*THE METROPOLITAN WATER DISTRICT  
OF SOUTHERN CALIFORNIA*

**Advisory Panel  
for the  
Potential Regional Recycled Water Program**

**Report No. 2:  
Feasibility Methodology  
Program and Infrastructure Review  
Groundwater Basin Assumptions**

**September 18, 2016**

# Current Demo Plant Configuration

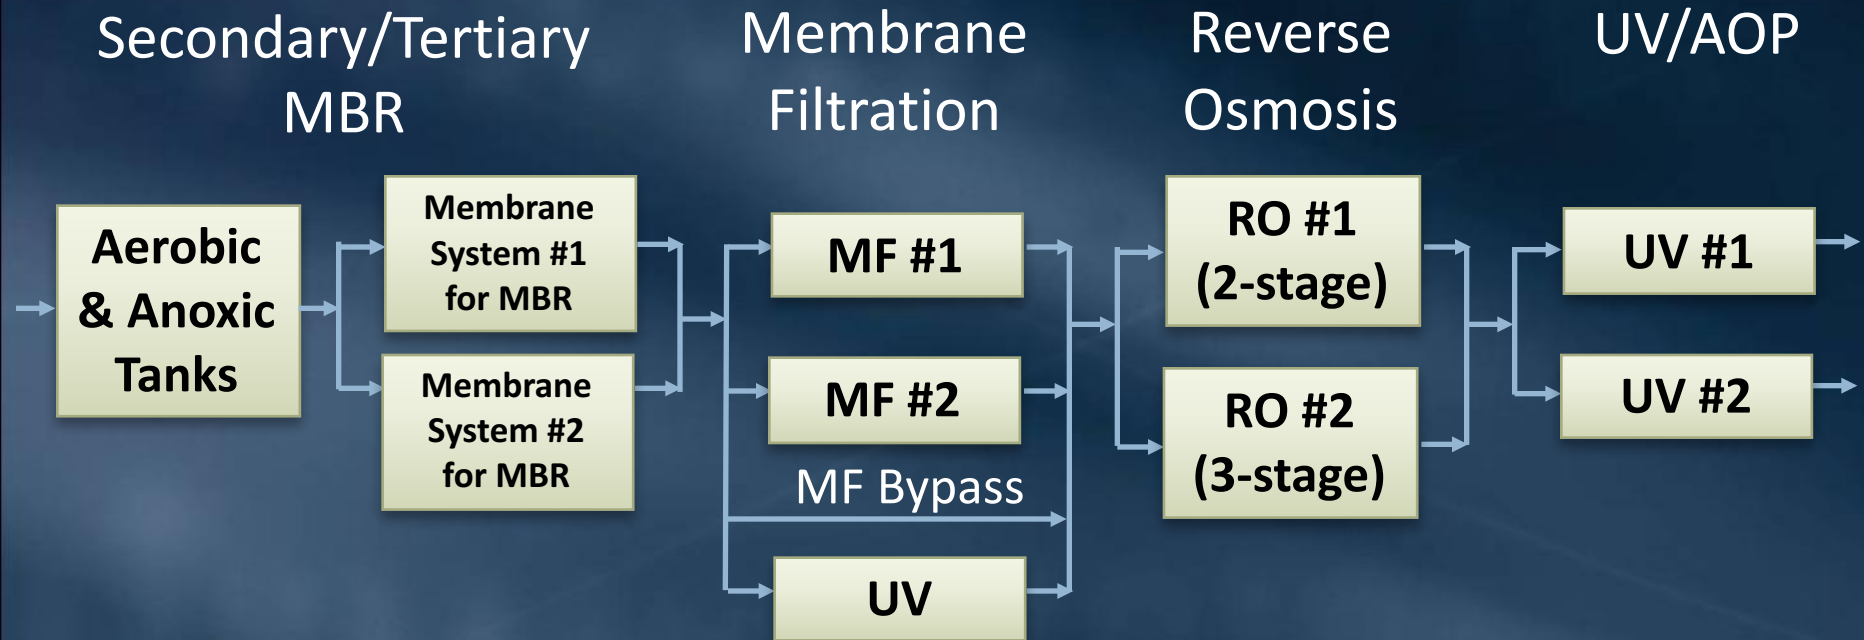
**Advisory Panel Comments.** The demonstration plant will use a two-pass RO system and a three-pass RO system in parallel for comparison. The panel agrees that the product water quality from either the two-pass RO system or the three-pass RO system will be similar.

The Advisory Panel questioned having two equipment vendors for each process when the trains are not separate. The Advisory Panel recommends that the Design Team confirm that the regulators are comfortable with there being more than one equipment vendor for each process.

The Advisory Panel suggests consideration of a short aerated zone upstream of the membranes to avoid anoxic water going directly to the membranes and creating risks of fouling.

The Advisory Panel agrees with the Design Team that the demonstration plant will be able to use several carbon sources (methanol and MicroC2000™). The treatment process should also include a phosphoric acid feed to prevent the biological process from being phosphorus limited.

# Full-Scale AWT Base Case Schematic

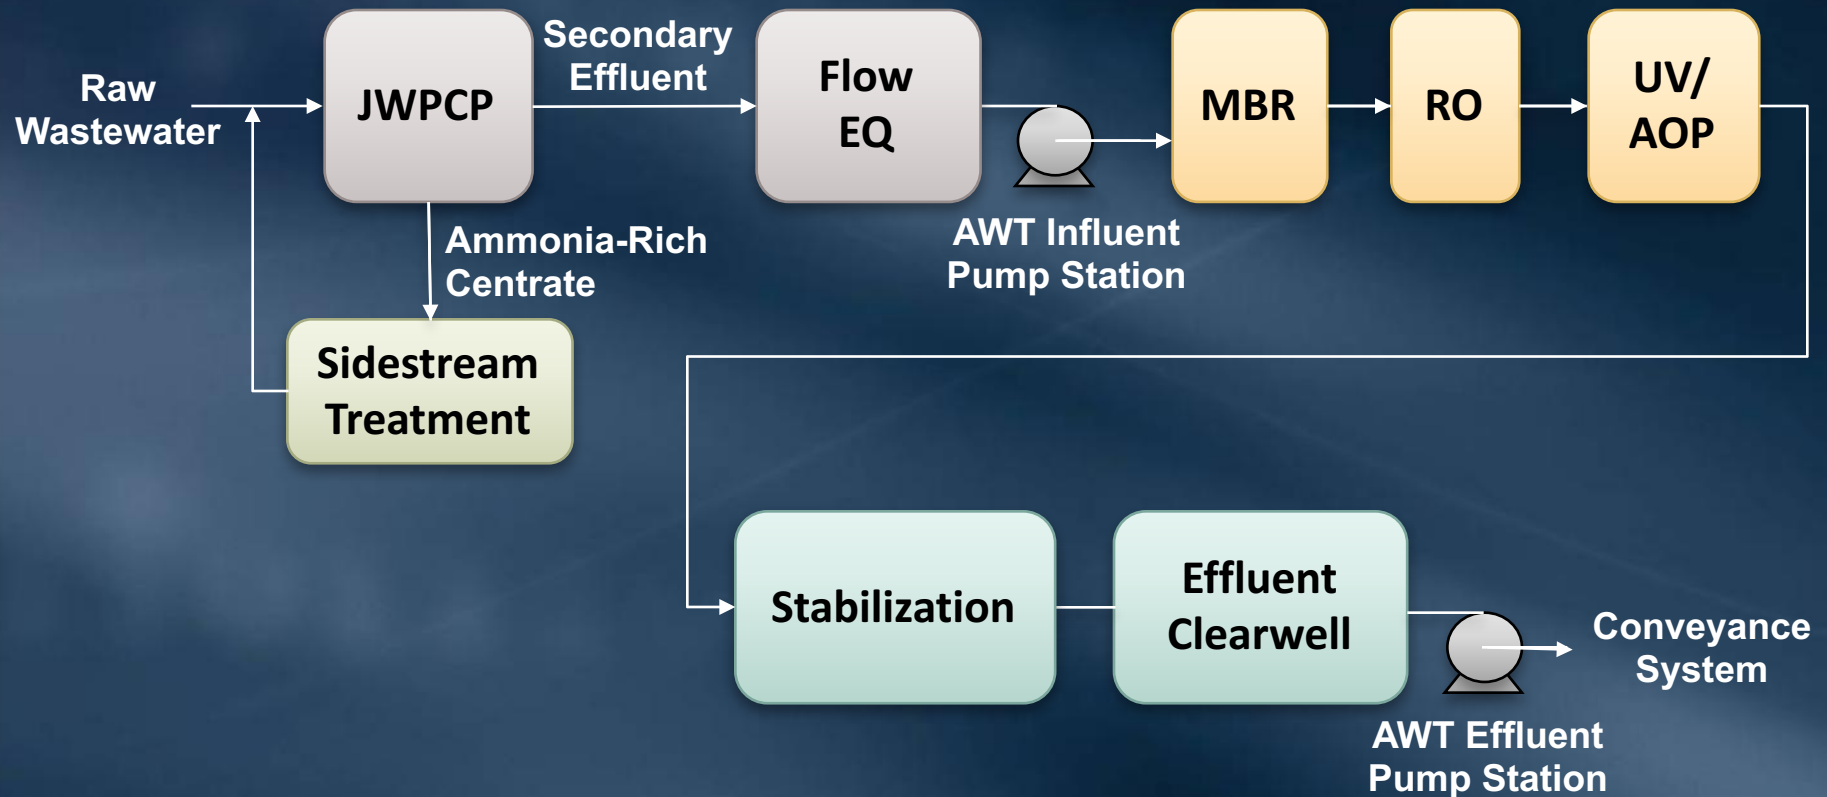
The Advisory Panel thought it might be too optimistic to exclude MF/UF after the MBR in the base case and encouraged the Design Team's current plan to have the demonstration plant provide the data both with and without MF in the treatment train. The panel supports the decision to allocate space for future MF in the full-scale layout if needed. This could also provide for the addition of MF to meet future potential DPR requirements.

The Advisory Panel commented that it may be appropriate to divert denitrified water, prior to RO-treatment, for non-IPR use near the JWPCP.

The Advisory Panel asked about where the secondary effluent flow equalization basin would be located. The Sanitation Districts indicated that flow equalization is still being evaluated. Existing clarifiers that are not needed for current reduced flow could potentially be used. The Advisory Panel inquired whether tankage used for equalization could also be used to start the process of nitrification by adding fixed-film media, air, and return secondary solids. The Design Team responded that this would be considered in future studies.

# Conveyance Base Case

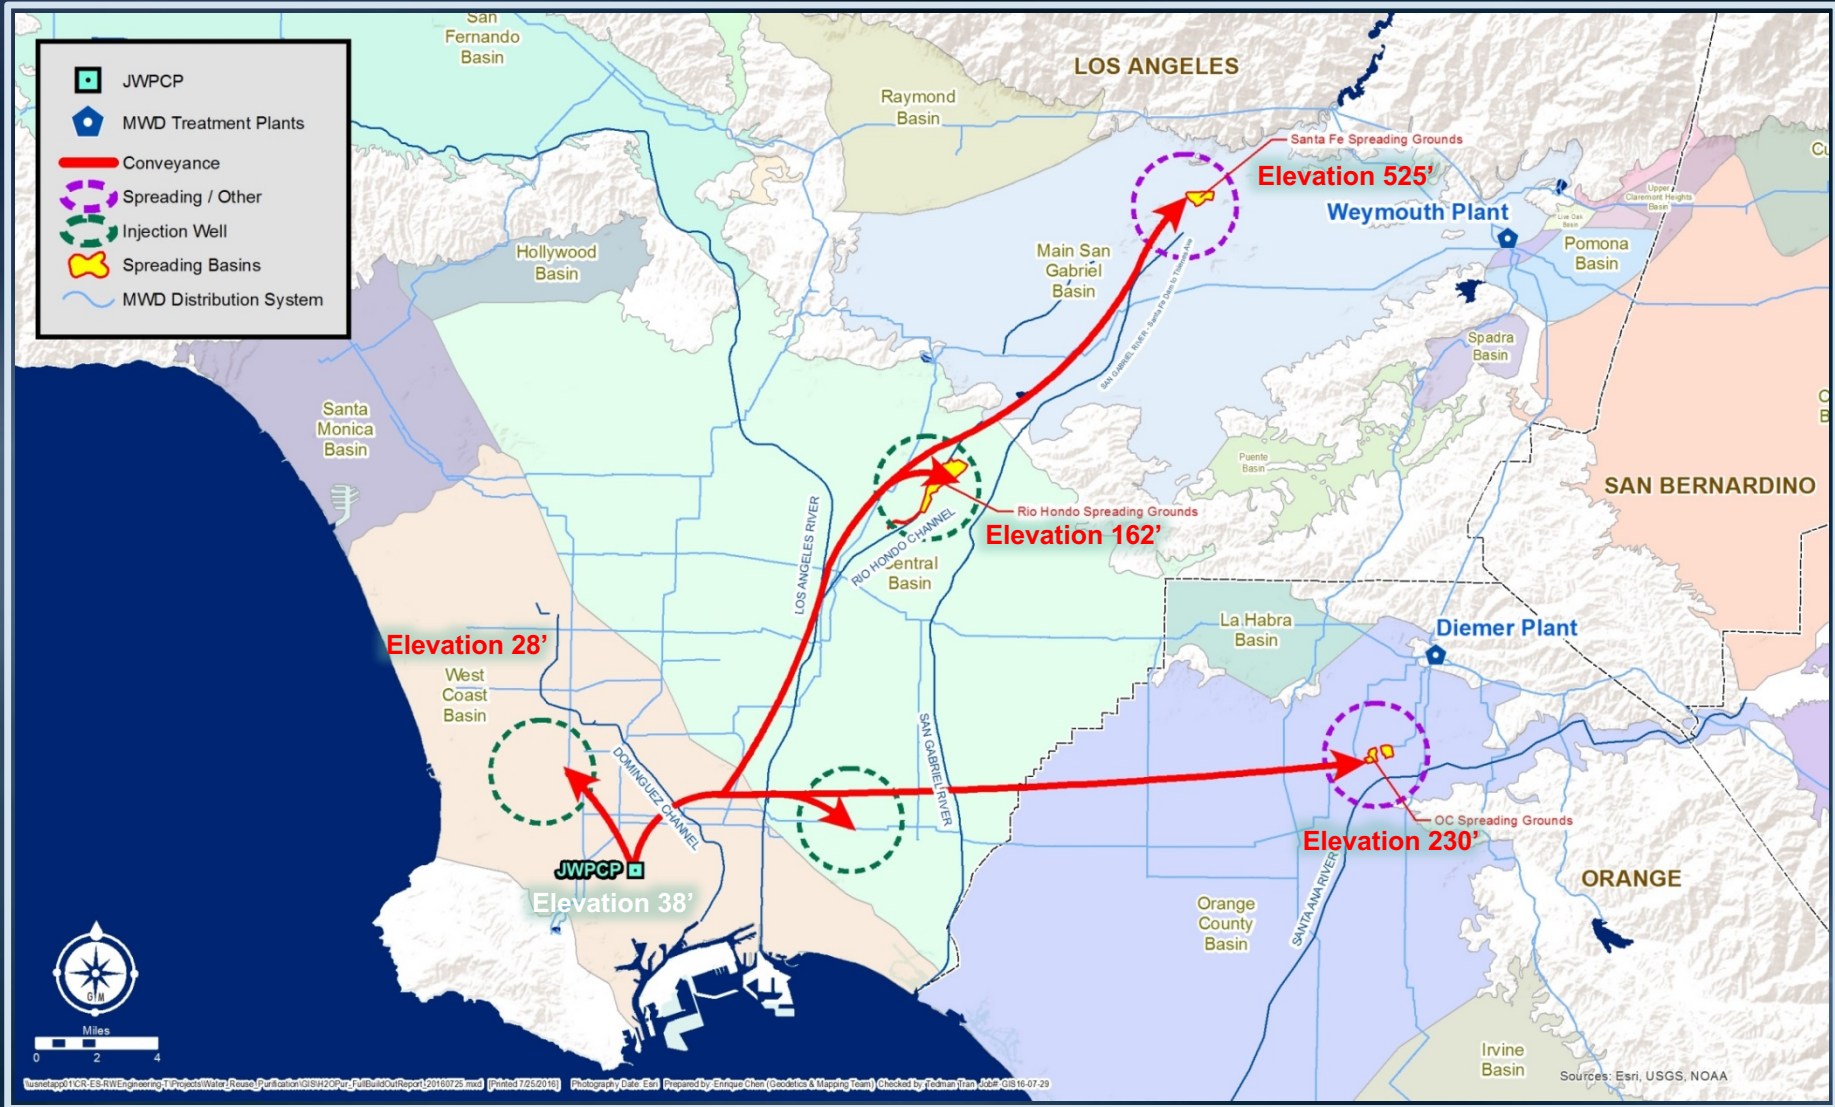
**Advisory Panel Comments.** The Advisory Panel noted that two Metropolitan surface water treatment plants are relatively close to the conveyance lines as shown in the base case. The panel suggests that at some future time and, with DPR regulations permitting, connection to existing Metropolitan raw water pipelines and ultimately the treatment plants may be possible. This would enhance the operational flexibility when full spreading capacity may not be available.

The Advisory Panel commented that the base case conveyance system is proposing cement mortar-lined pipes, which have been a problem for OCWD. Even if the AWT facility is designed to produce stable water quality with post-conditioning, this is not always achieved in practice and a robust conveyance material is important. The panel suggested use of high density polyethylene pipe, but this material has size and pressure limitations. Fiberglass pipe, per AWWA C-950, may be suitable; it is available in large diameters and various pressure classes. The panel also noted that activated sludge effluent is aggressive and must be accounted for in the materials and budgeting. The panel recommends that a robust, non-corrosive pipeline material or lining *in lieu* of cement mortar lined steel be considered during design.

The Advisory Panel recommends that planning for the conveyance system should be flexible and account for future possible sources of water such as other reuse projects, desalination, DPR, etc. The conveyance system must be coordinated with existing water supply and recycled water facilities, other planned projects, and other possible sources, including the conveyance for the Water Replenishment District's Groundwater Reliability Improvement Project. Since these projects are likely to occupy the same space along the San Gabriel River levee, there may be a potential for joint ownership. Coordination with the Los Angeles County Flood Control District, Army Corps of Engineers, other utilities and cities will be needed during conveyance system planning.
